MBB (Material Barrier Bag) : extend print out warning message on shelf life

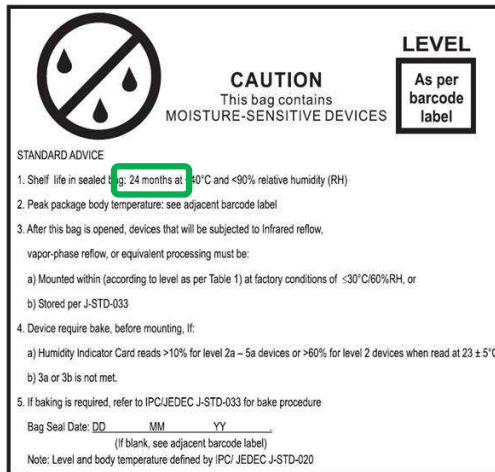
Due to historical reasons, the MBB ST is providing for SMD (Surface Mount Device) products have printed advise message alerting on 12 months of shelf life in sealed bags.

To align with extended shelf life International trends, the print out advise message for SMD products and in any case all products packed with MBB will be changed alerting on 24 months of shelf life in sealed bags.
